DOCKET	
08-AFC-11	
DATE	<u>08/19/09</u>
RECD.	<u>08/19/09</u>

Subject: Fwd: RE: July Response to CEC staff Data Requests for Noise (#54)

**FIGURE DR54-1
SUPPLEMENTAL NOISE
MONITORING LOCATIONS**
CPV VACA STATION
VACAVILLE, CA

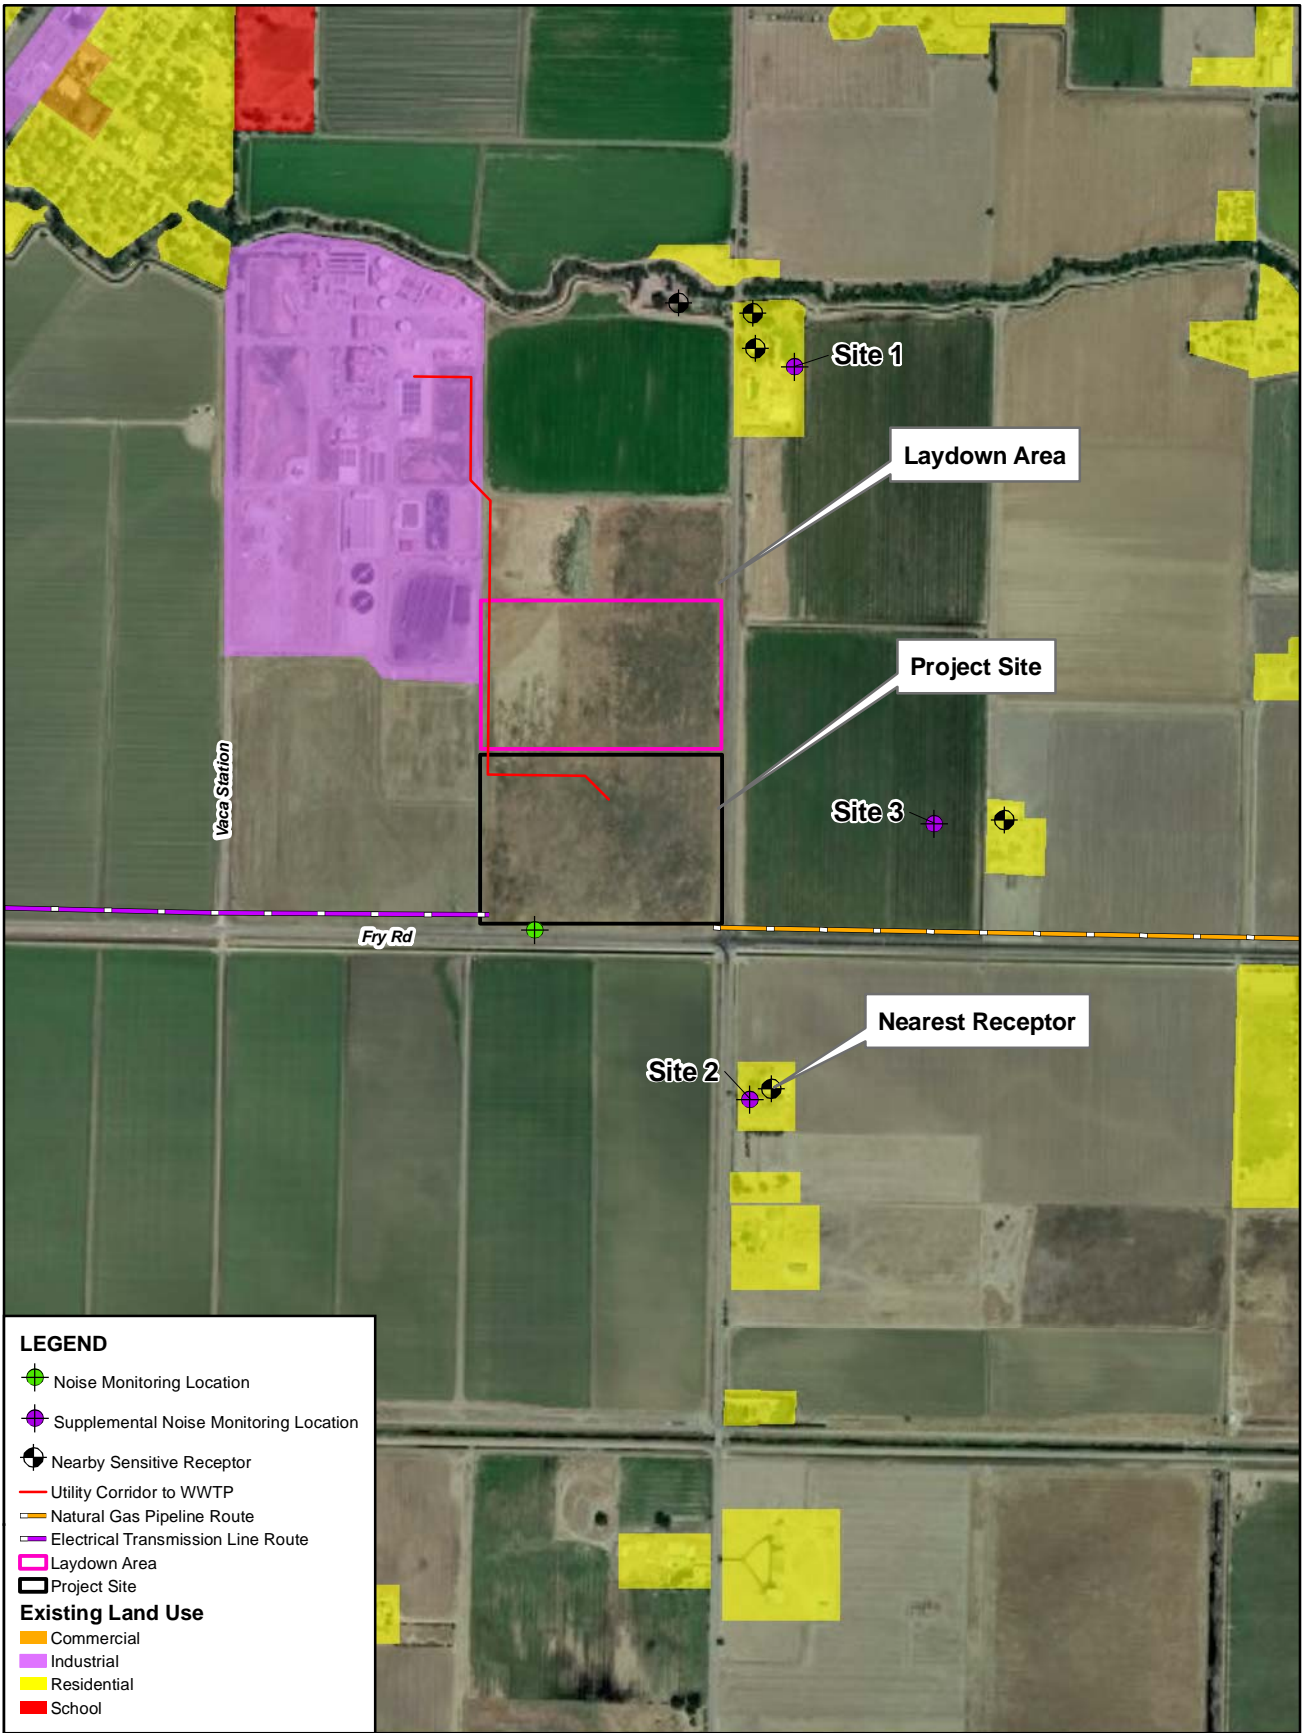
Doug - I'm following up on the e-mail sent to you last Thursday regarding Figure DR54-1. Is the map being updated?

Hi Doug - Shahab Khoshmashrab who is working on the Noise section of the PSA stated that it's unclear which residences shown in Figure DR54-1 Noise Monitoring Location are the ones discussed in your response to questions 54, with the exception of the nearest receptor. Can you have the map revised and e-mail a new version to me?

Here is the revised and corrected noise monitoring location figure for CPV Vaca Station Data Request #54. Please let me know if Staff has other questions or requires additional information.
